SUNDRY NOTICES AND REPORTS ON WELLS

J. L. KEEL "A" #22

30-015-28047

SUNDRY NOTICE SPECIAL STIPULATIONS

DEVON ENERGY CORPORATION WELLBORE SCHEMATIC

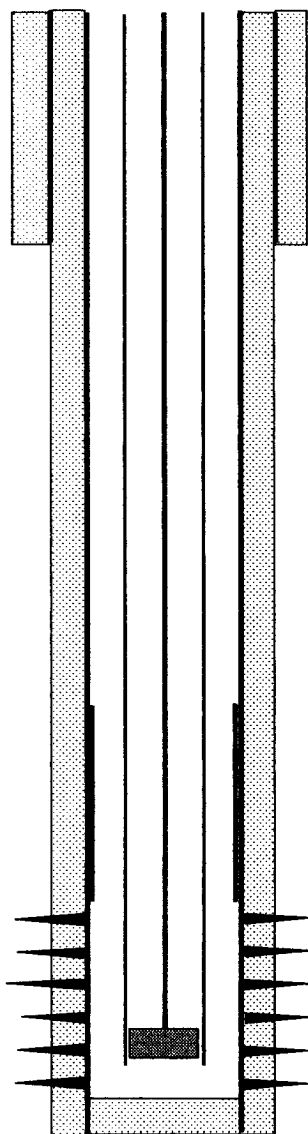
1. Approval is granted to P/A this well with the following modifications to the procedure:
2. The plug proposed for 1525' should be moved to 1408' for the base of the salt.
3. The plug proposed for 485' should be moved to 578' for the top of the salt and the 8.625" casing shoe.
4. The plug proposed for 63' should be moved to 100' or the tag depth of the plug @ 578', whichever is more shallow.

*** All plugs, including the surface plug, should leave at least 25 sacks of cement inside the casing and be at least 100 feet, plus an additional 10% for each 1000 feet of depth.**

Plugging procedures must conform to 43 CFR 3162.6.d and Onshore Order No. 2.III.G or NMOCD orders if they are more stringent.
